Comment Response Letter

Subject: 15650 Los Gatos Blvd
Consulting Architect Comment Response letter

Responses to Consulting Architect comment letter dated 05.04.2022 are following each comment.
Responses prepared by Kenneth Rodrigues and Partners in **Blue**.

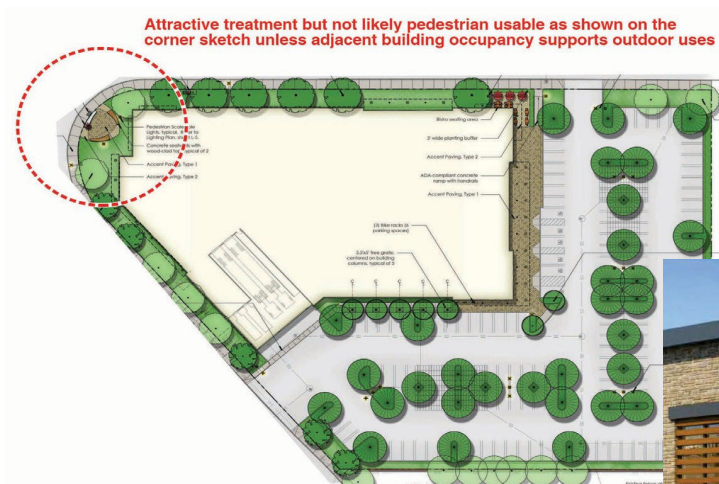
2. The proposed treatment at the intersection corner of the site appears attractive, but not likely pedestrian- usable as shown on the corner sketch below unless the adjacent building occupancy supports outdoor uses.

- The strong contrast of color on the central portion of the Los Gatos Blvd. facade and on the truck loading dock area would draw the eye like a focal point, and would disrupt the well-done design unity of the rest of the structure. Likewise, the window treatments (i.e., transparency) on all sides of the structure will depend on the tenant's interior uses.

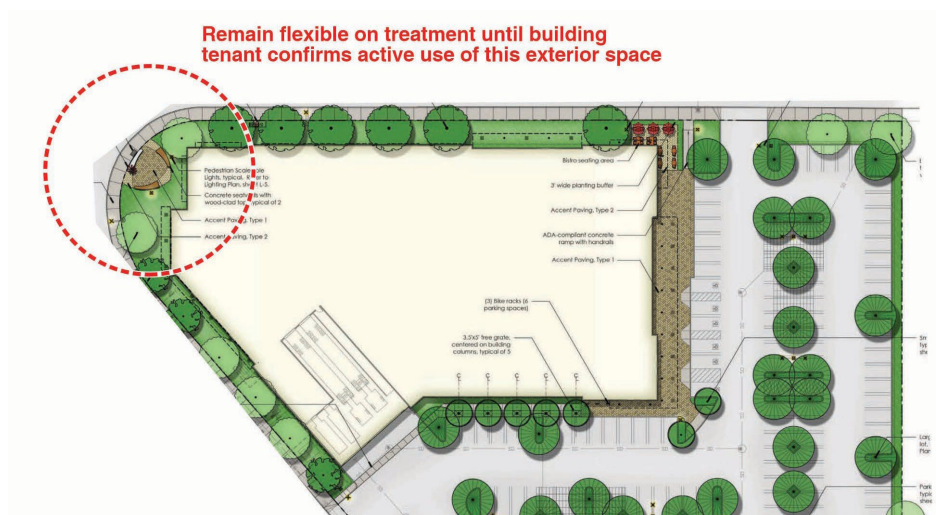
- Add a landscape divider at the Los Gatos-Almaden Road project entry if possible

A landscape divider cannot be added since the truck turning movements need to utilize the entire driveway.
